NOTICE TO ALL BIDDERS

**ADDENDUM NO. 2
TO
TUCSON AIRPORT AUTHORITY
TUCSON INTERNATIONAL AIRPORT
10219007 CBP RELOCATION**

January 23, 2019

LARGE SCALE PLANS
TAA Executive Terminal
CBP Relocation TAA project #10219007

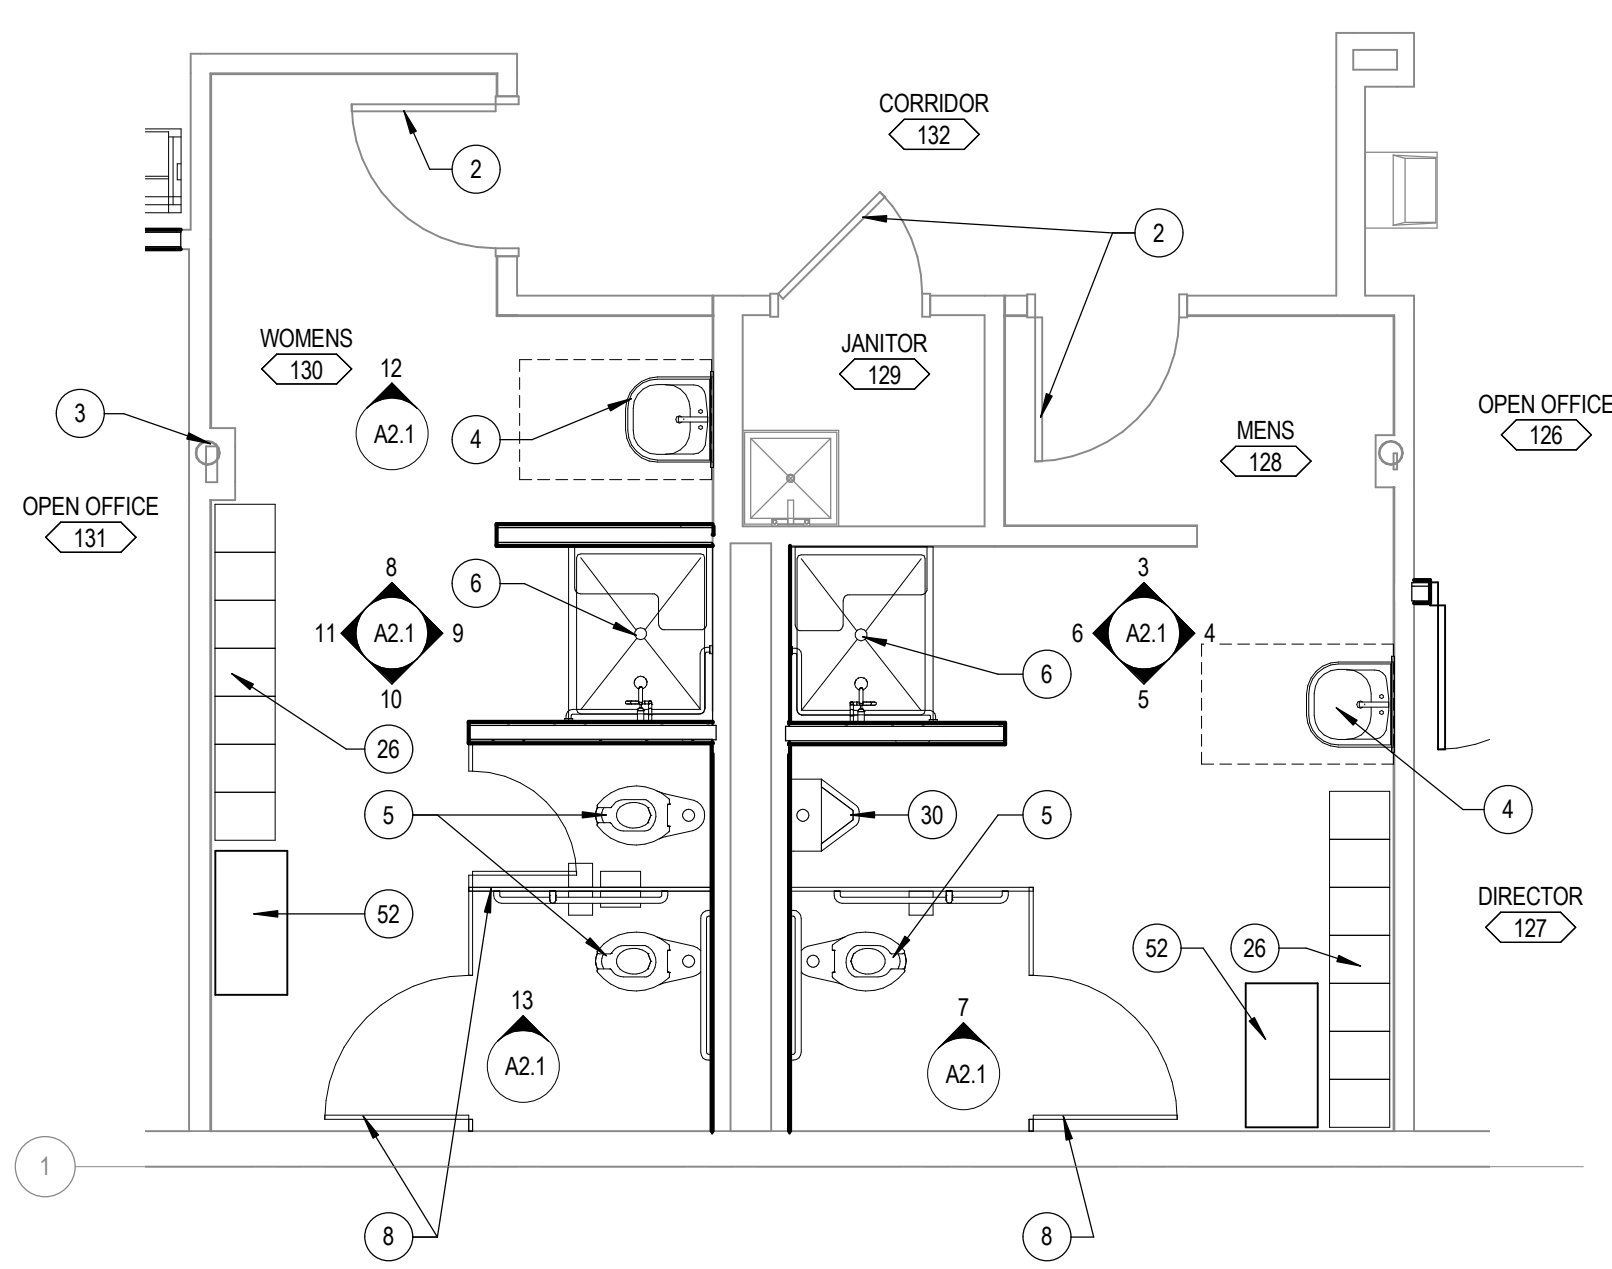
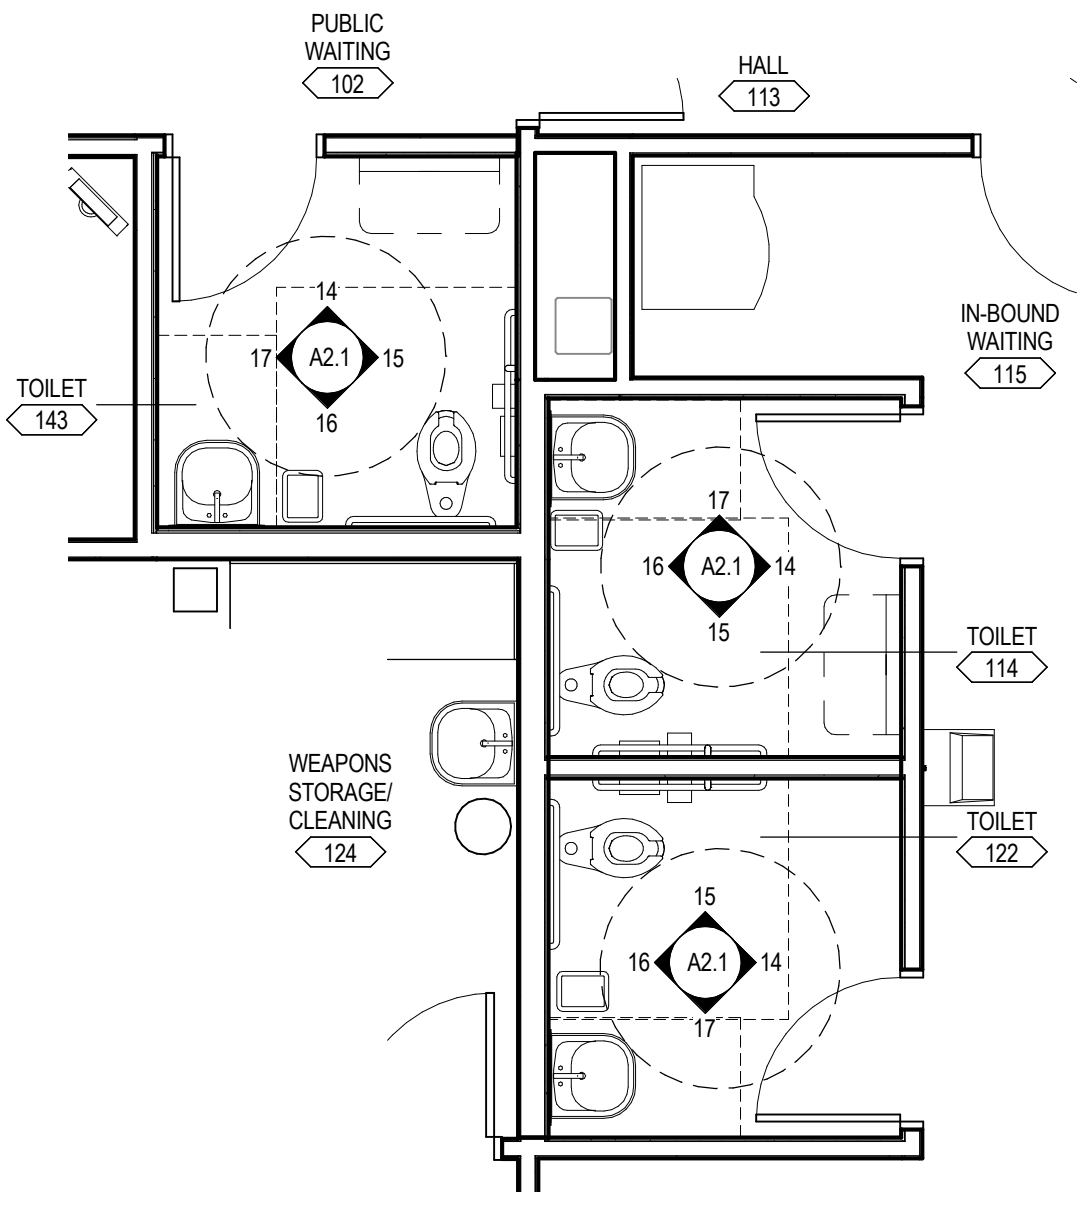
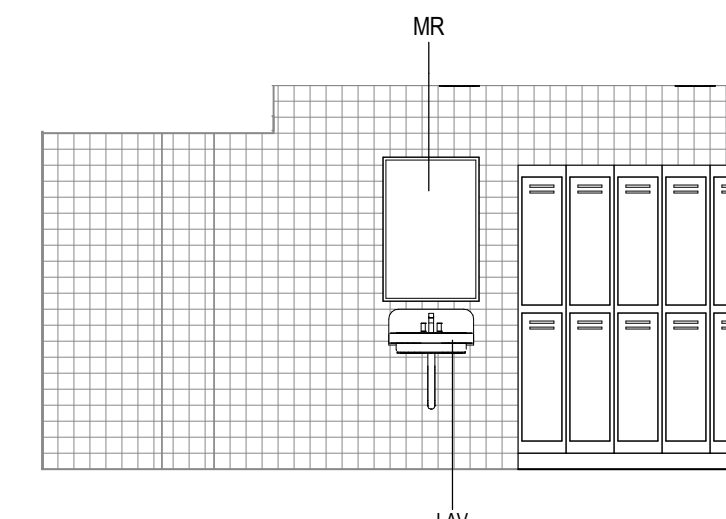
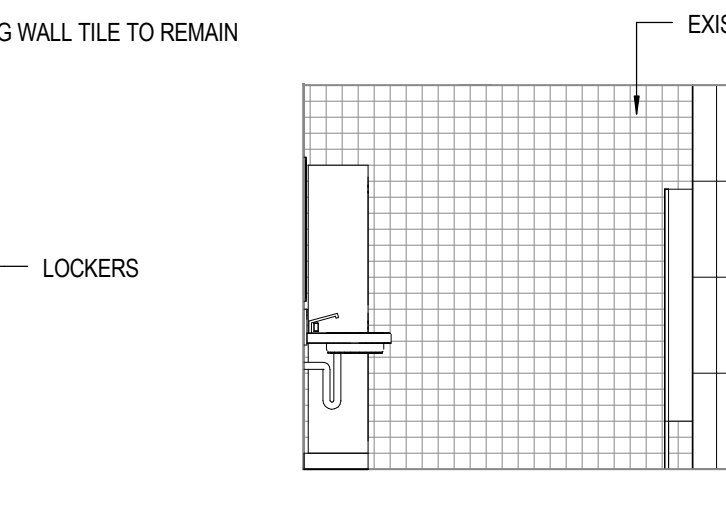
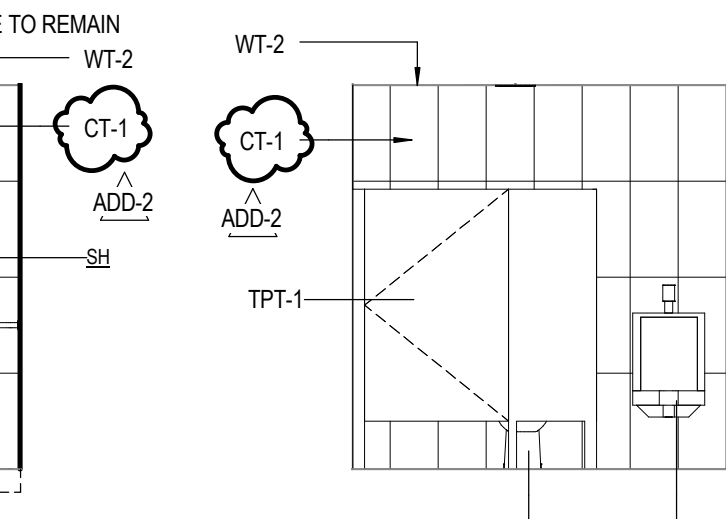
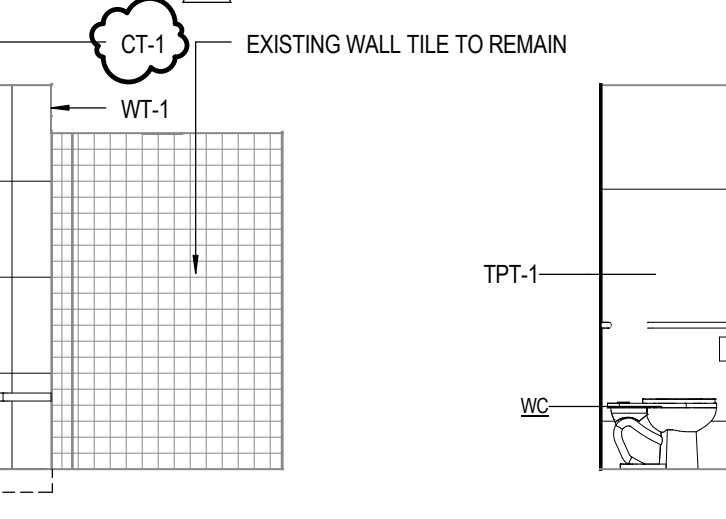
On sheet A2.1 wall tile is indicated as CT-2. Specification 09 3013 indicates CT-1. Please clarify.

- A. Modify drawing per attachment A2.1 of Bid Addendum #02 dated January 23rd, 2019
- Keynotes 24 and 25 modified to reflect relocation of the stainless steel tables and benches.
 - Keynotes 26, 27 and 36 have been updated to clarify owner furnished and contractor furnished items.
 - References to CT-2 on the interior elevations have been updated to CT-1 to match specifications.

Response: CT-1 is correct, A2.1 will be updated.
